*Riverfront Phase IIB  
Fort Wayne, IN*

***ADDENDUM #2***

**ADDENDUM NO. 2**

**ISSUED DATE:** October 17, 2024  
**PROJECT:** Riverfront Fort Wayne – Phase 2  
**LAND COLLECTIVE PROJECT NUMBER:** No. 1818

DETAIL OF LIGHT STANDARD FOUNDATION

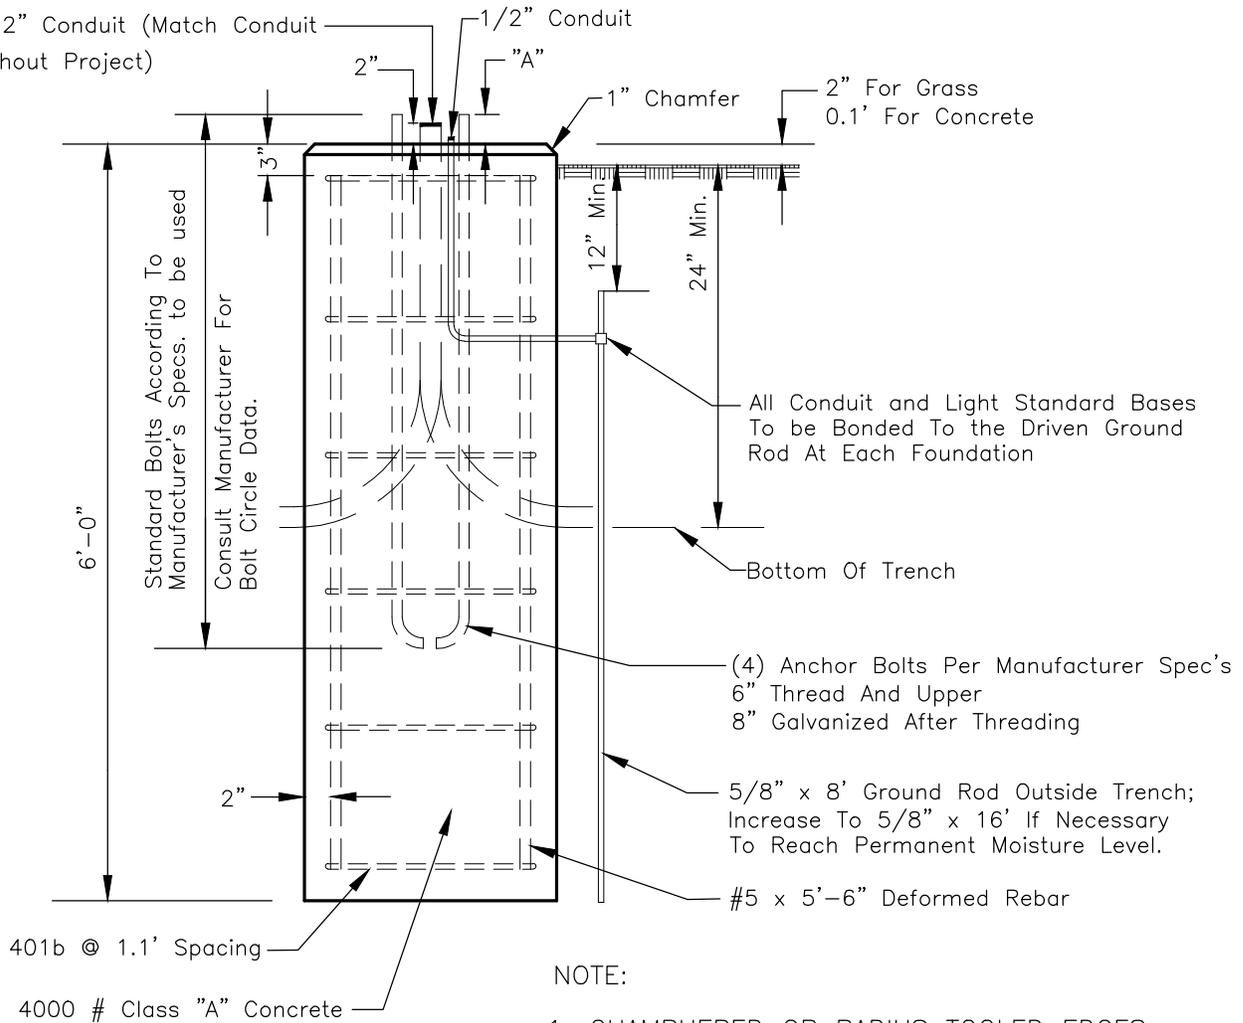
028	Pending	the storm piping that runs between structures EX-209, ST-230, and ST-230A is called out to be 15" RCP. However, structures ST-230 and ST-230A are proposed to be 12" Nyloplast. Please advise on how to provide due to the pipe being larger than the structure.	Hagerman	A/E Team	10/9/2024	10/18/2024	Change 15" RCP to 15" HDPE.
029	Pending	E220 Note P14 need to know feeder size for sluice gate. No breaker is indicated in panel LP1 for sluice gate.	Hagerman	A/E Team	10/11/2024	10/18/2024	Added Plan note P10 in Addendum#2
030	Pending	E230 Alternate #2 Looks like drawing also shows Alt# on sheet E220 separation between both alternates is needed.	Hagerman	A/E Team	10/10/2024	10/18/2024	Added separation lines in Addendum #2
031	Pending	E601 Luminaire schedule need to know city standard for concrete light pole bases for L01 & L01B.	Hagerman	A/E Team	10/10/2024	10/18/2024	Added the pole base detail in Addendum #2

DATE: 16 SEPT 24  
SCALE: 1" = 20'-0"  
SHEET NO.: C103  
LC JOB NO.: 1818

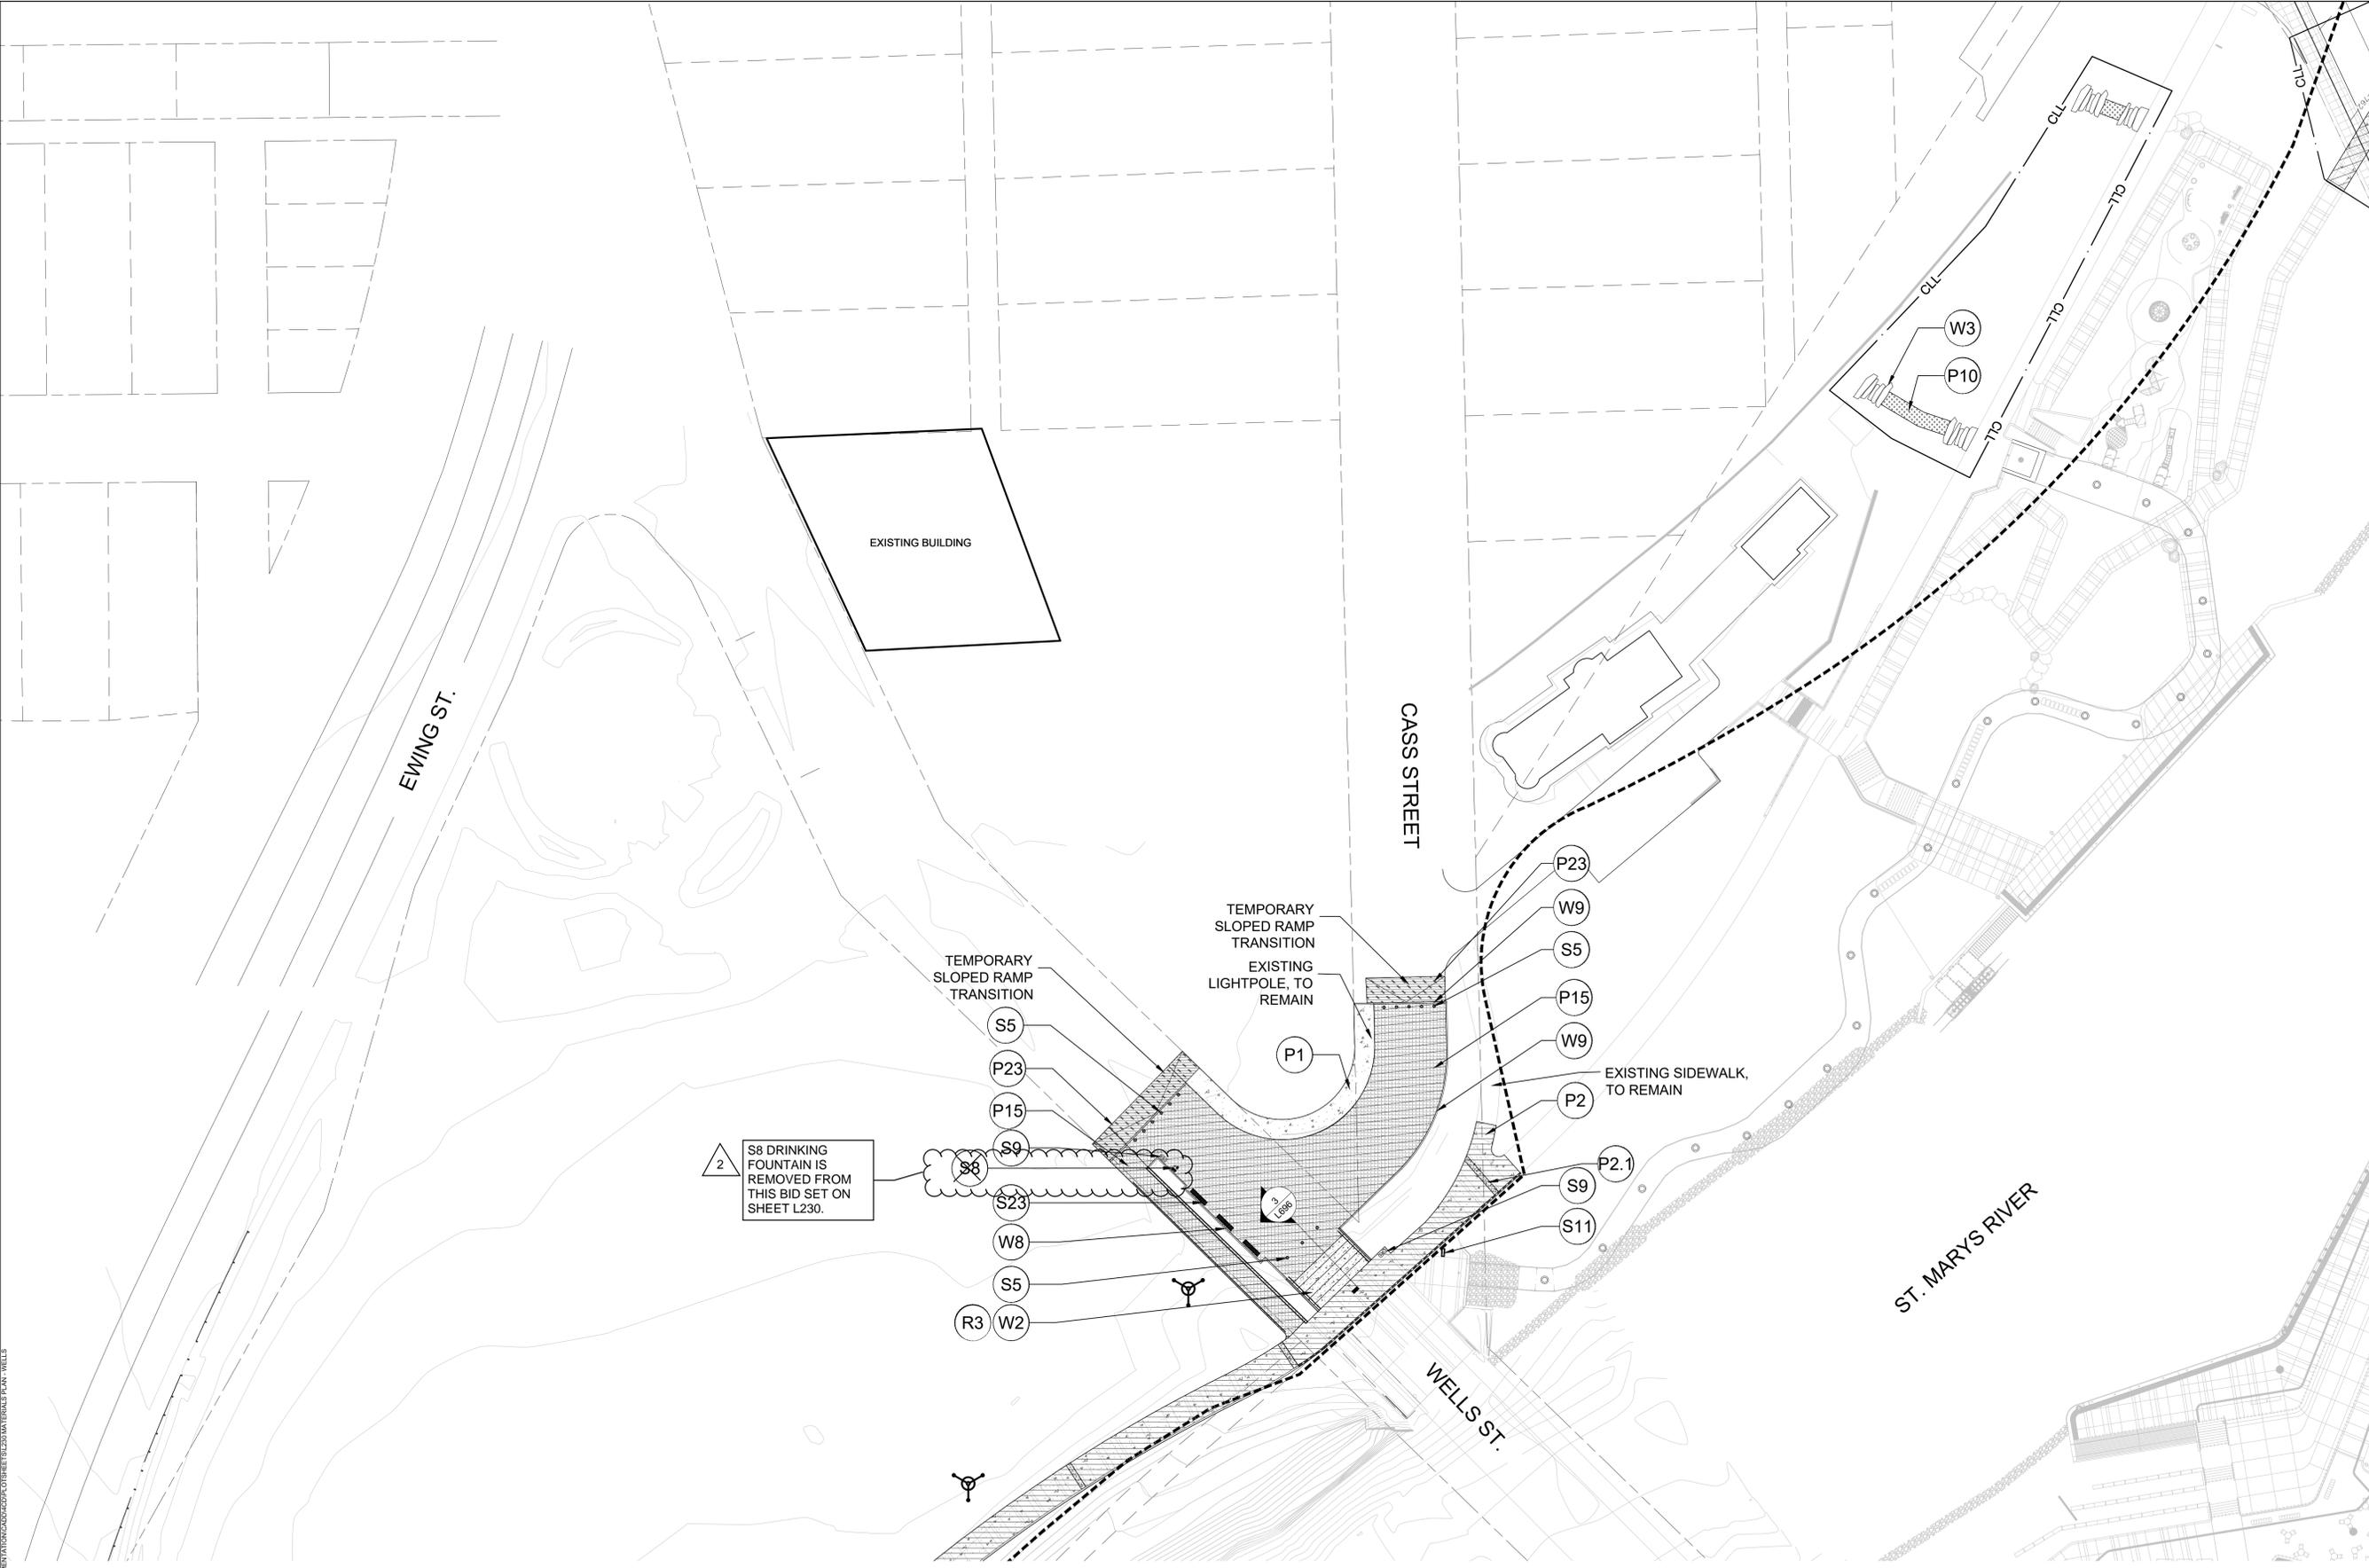
**DRAWING CHANGES**C103

- Updated sheet scale label and scale bar.

DATE:	SHEET NO.:
16 SEPT 2024	<b>L600</b>
SCALE:	
VARIES	
LC JOB NO.:	
1818

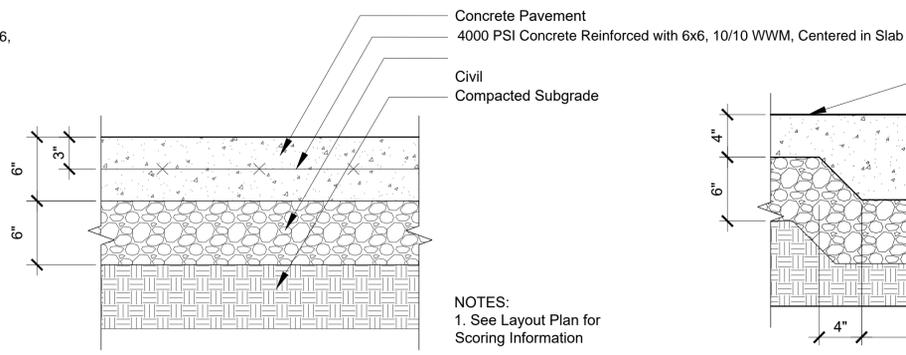
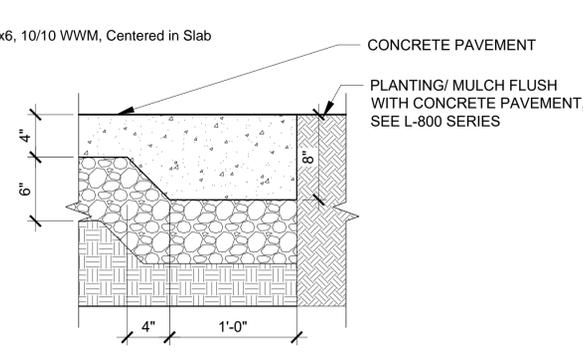
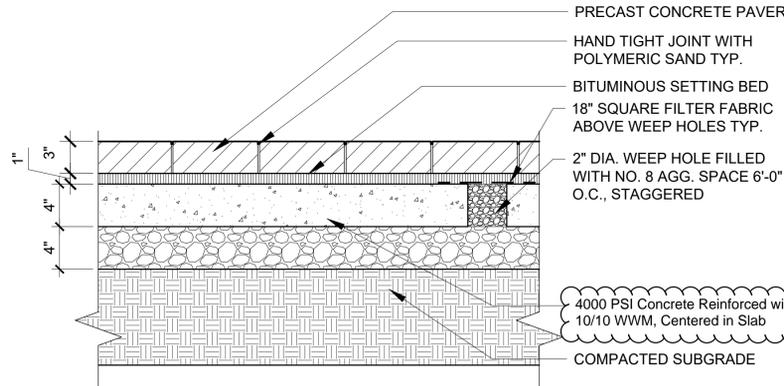
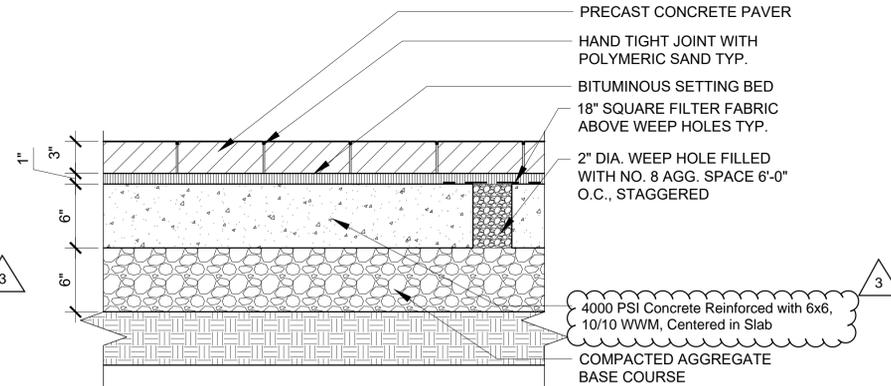
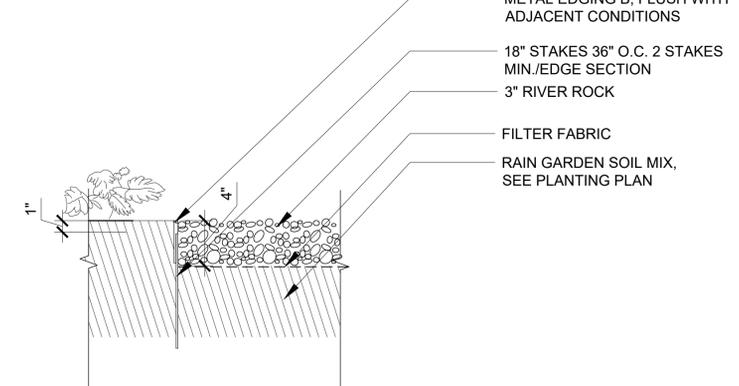
L600

- Updated reinforcement information on details #9 and #10.

### Pole Base Detail 'C'

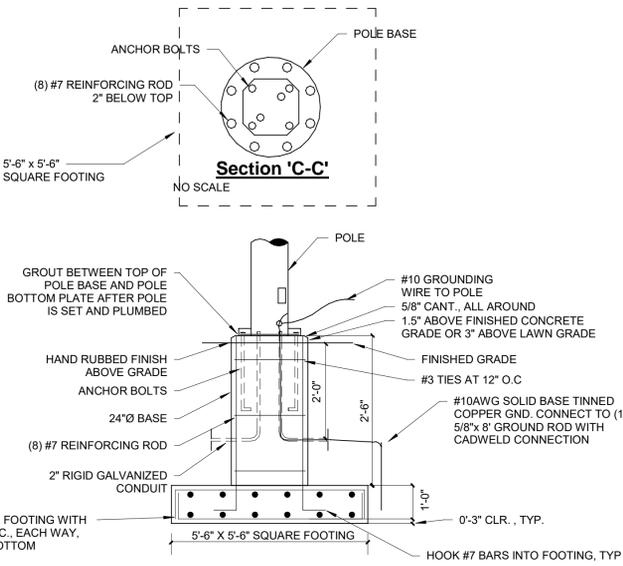
- RFI #29 – See Plan note P10 on Attached E220
- RFI #30 – Provided separation lines between Wedge and Wells Street
- RFI #31 – See attached City Pole base detail.

## Electrical Plan - Wedge Embankment

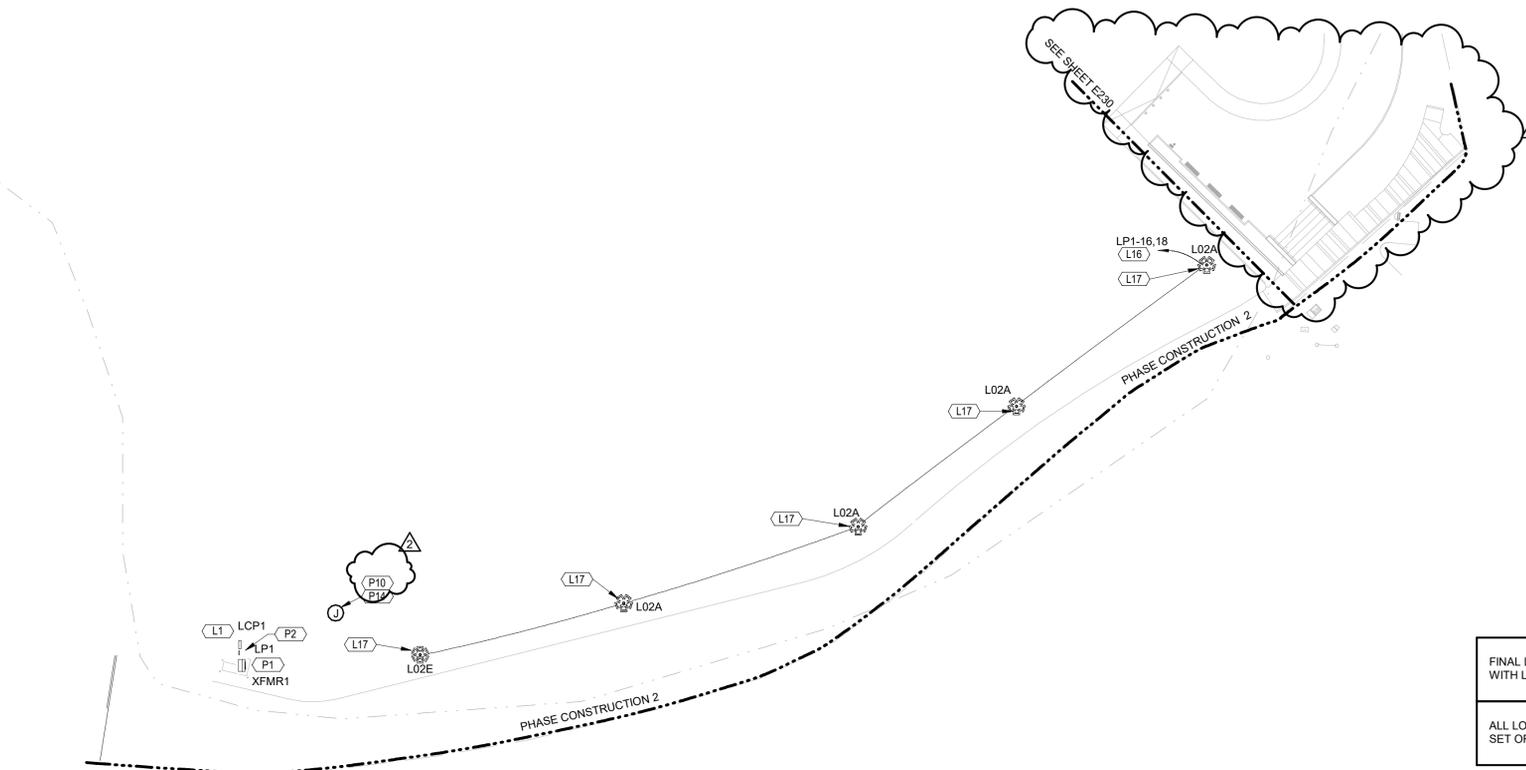
E220

- Added plan note P10 to clarified refeeding the sluice gate.
- Provide a clear separation between the Wedge and Well's Street.
